CITY OF ALBUQUERQUE

Re: Art Barn
1904 Bellamah NW
Traffic Circulation Layout
Architect's Stamp XX-XX-XX (J13D205)

Based upon the information provided in your submittal received 8-1-17, the above referenced plan cannot be approved for Building Permit until the following comments are addressed:

A1 TRAFFIC CIRCULATION LAYOUT
1" = 20'-0"

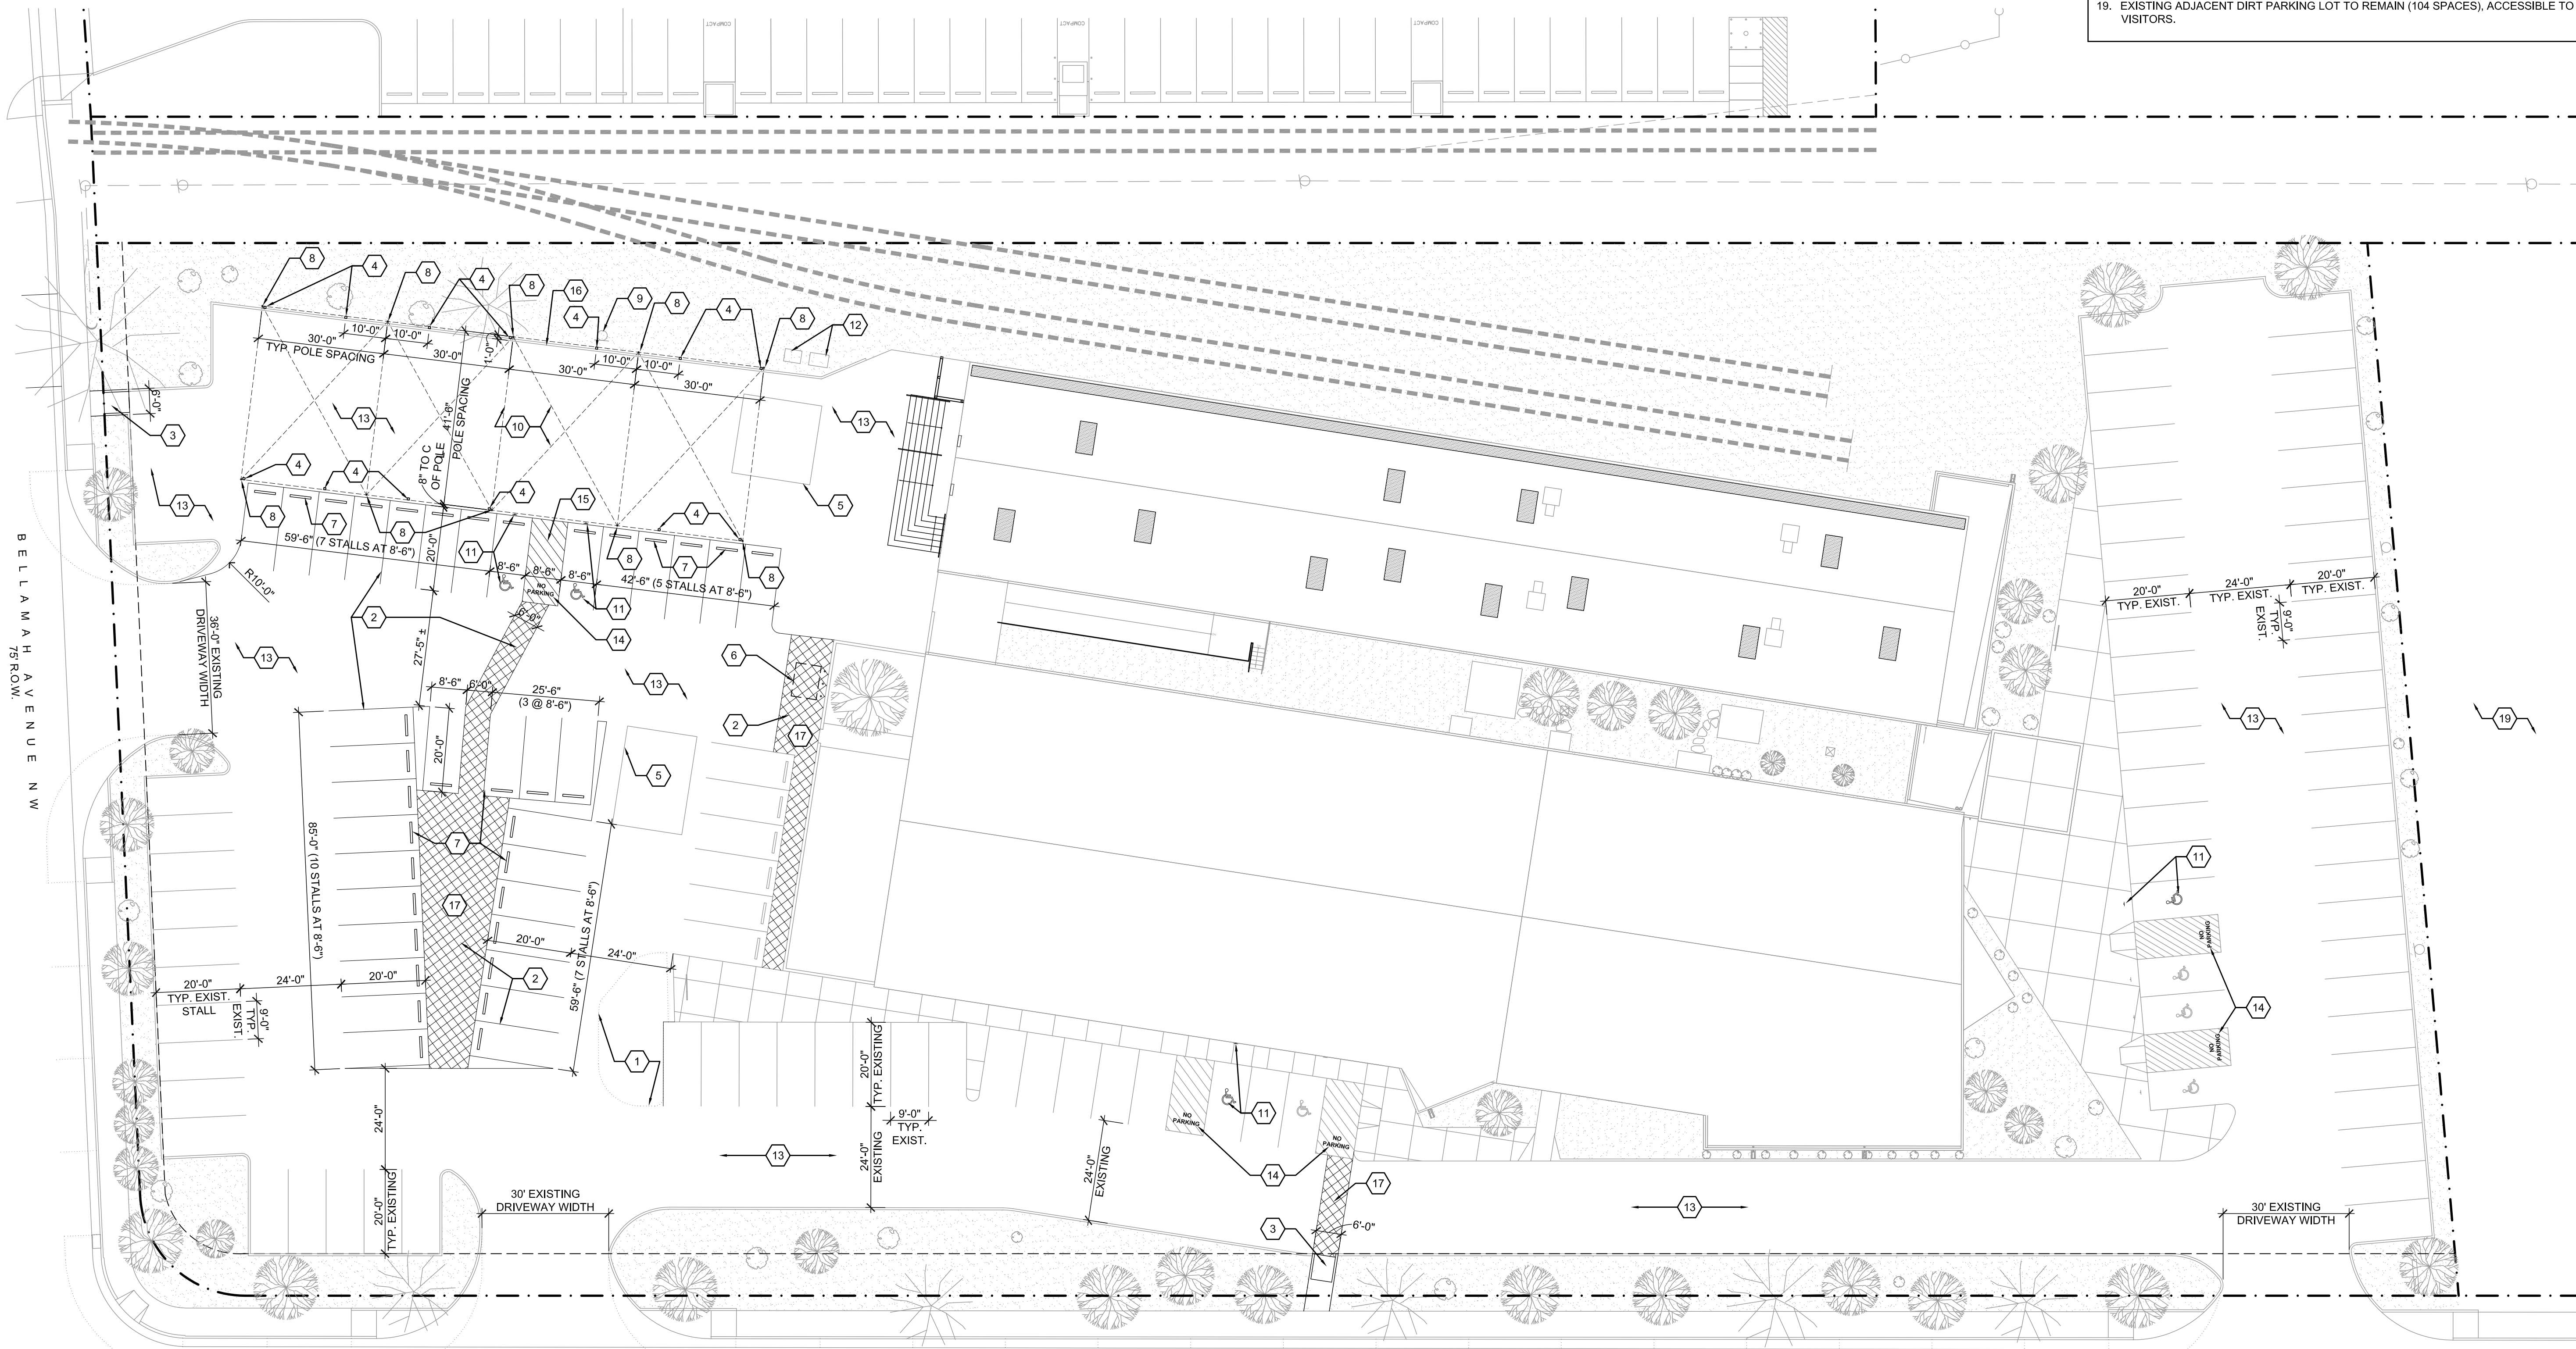
1. The traffic circulation layout must be stamped, signed, and dated by an engineer or architect licensed in the state of New Mexico.
2. Please include a copy of your shared parking agreement with the adjacent property owner.
3. On-Street parking credit to fulfill zoning's parking requirement must be requested and approved by the Traffic Engineer, Racquel Michel prior to TCL approval. The application requires at least 45 working days. On-street parking credit is based on available parking along public right-of-ways fronting the property. The business will only be granted 50% credit for available street parking.
4. All ADA accessible ramp in COA R.O.W. shall have detectible warning surface that meet COA standard.
